No. 1122
ATA Code 76-10

SUBJECT: ENGINE CONTROLS - INSTALLATION OF IMPROVED FEATHERING STOP SPRING

EFFECTIVITY: BEEHCRAFT Duchess 76, serials ME-1 through ME-299.

Service Instructions No. 1122

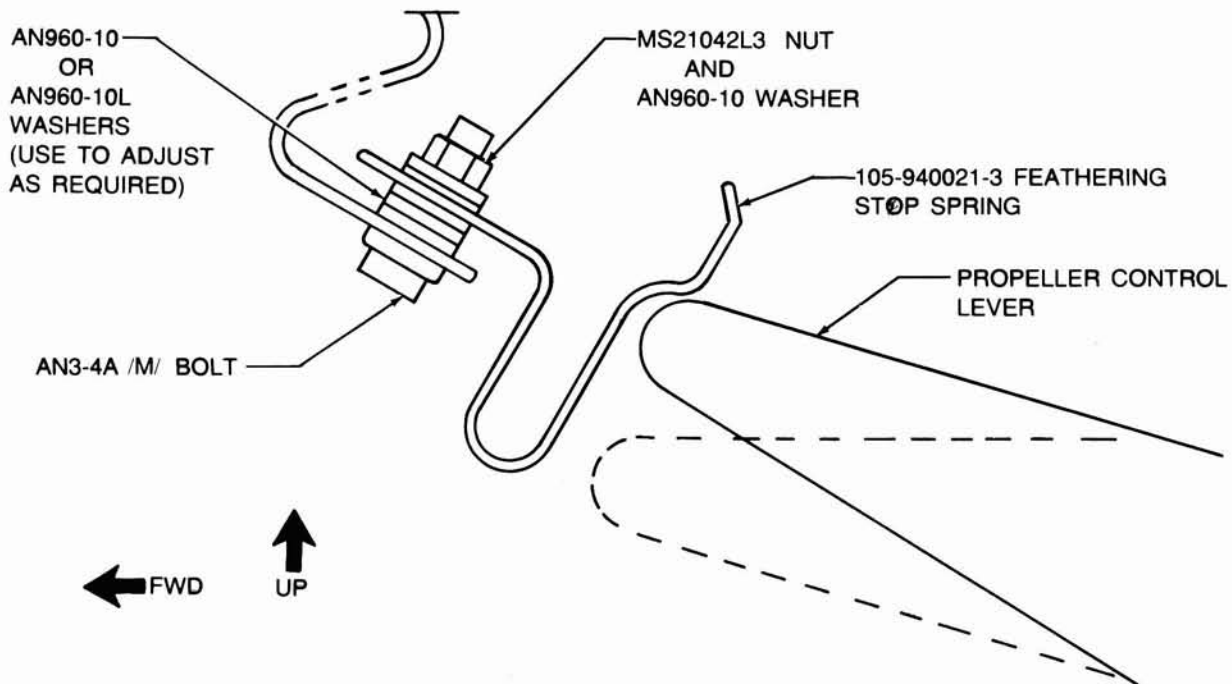
4. Remove the P/N 105-940021-1 feathering stop spring and install the new P/N 105-940021-3 stop spring.

5. Adjust the new feathering stop spring as necessary to obtain proper detent action with the propeller control levers (see illustration). The elongated holes in the feathering stop spring allow adjustment forward and aft for proper detent action.

6. To check for proper vertical adjustment, refer to the Pilot's Operating Handbook and FAA Approved Airplane Flight Manual starting procedures and ground run both engines. Pull the propeller control levers back until they contact the feather stop detent. Do not pull the propeller levers into the feather position. Slowly move the throttles forward until the rpm stabilizes. The rpm reading should be 2000 ± 25 rpm. If adjustment is necessary, add or remove washers as necessary under the feathering stop spring (see illustration).
